SHINE Technologies, LLC Application for an Operating License  
Supplement No. 10 and Response to Request for Additional Information

#### SHINE TECHNOLOGIES, LLC APPLICATION FOR AN OPERATING LICENSE SUPPLEMENT NO. 10 AND RESPONSE TO REQUEST FOR ADDITIONAL INFORMATION

#### RESPONSE TO REQUEST FOR ADDITIONAL INFORMATION

**Figure 11.1-3 – Radiation Protection Organization**

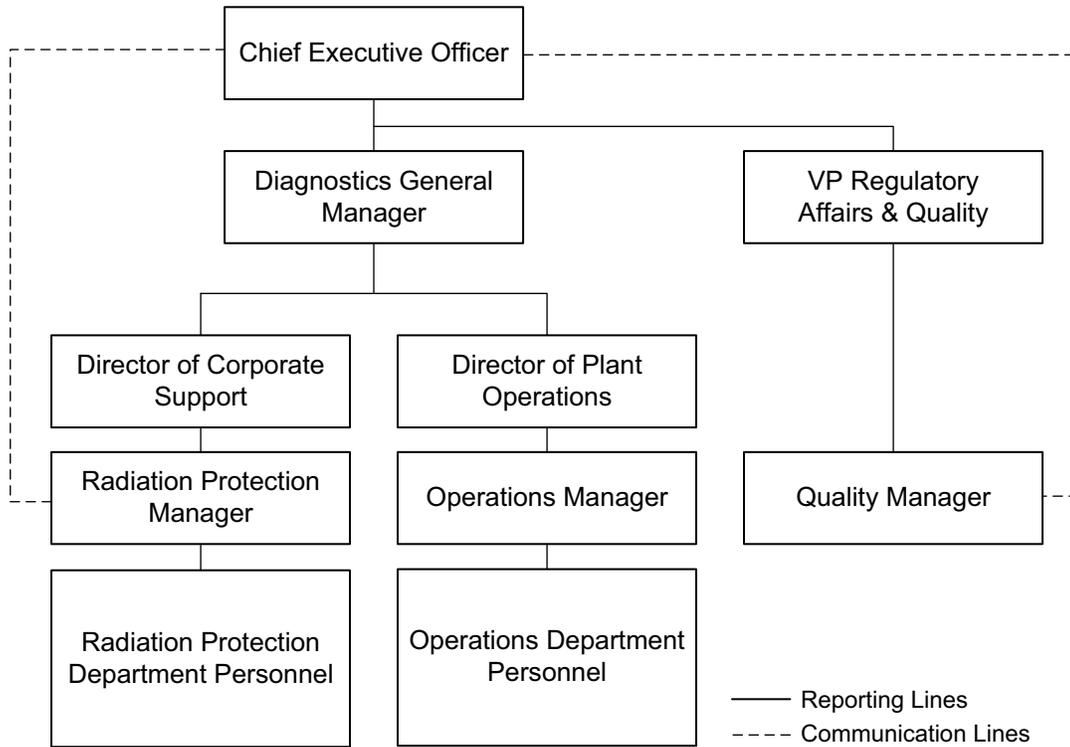
<b>Summary Description of Changes</b>	<b>FSAR Impacts</b>
Update to the organizational structure affecting titles, responsibilities, and reporting relationships.  Section 5.1, Figure 5.1.1, and Section 5.2, of the technical specifications have also been revised to incorporate these organizational structure changes.	Section 11.1, Section 11.2, Figure 11.1-3, Section 12.1, Section 12.2, and Figure 12.1-1
Update to audit activities to include nuclear criticality safety program audit requirements, consistent with Section 5.2 of the technical specifications and the SHINE Response to RAI 6b.3-18 (Reference 1).	Section 12.2

The Director of Corporate Support (DCS) is responsible for the protection of personnel from radiation exposure resulting from facility operations and materials, and for compliance with applicable NRC regulations and the facility license. The Plant ManagerDCS designates the authority to approve procedures related to personnel radiation protection to the Radiation Protection Manager in accordance with the guidance provided in ANSI/ANS-15.1-2007 (ANSI/ANS, 2007). The Plant ManagerDCS reports to the COODGM.

The Radiation Protection Manager is responsible for implementing the radiation protection program. The Radiation Protection Manager reports directly to the Plant ManagerDCS, independent from facility operations. The Radiation Protection Manager has direct access to executive management for matters involving radiation protection. The Radiation Protection Manager and radiation protection personnel are responsible for:
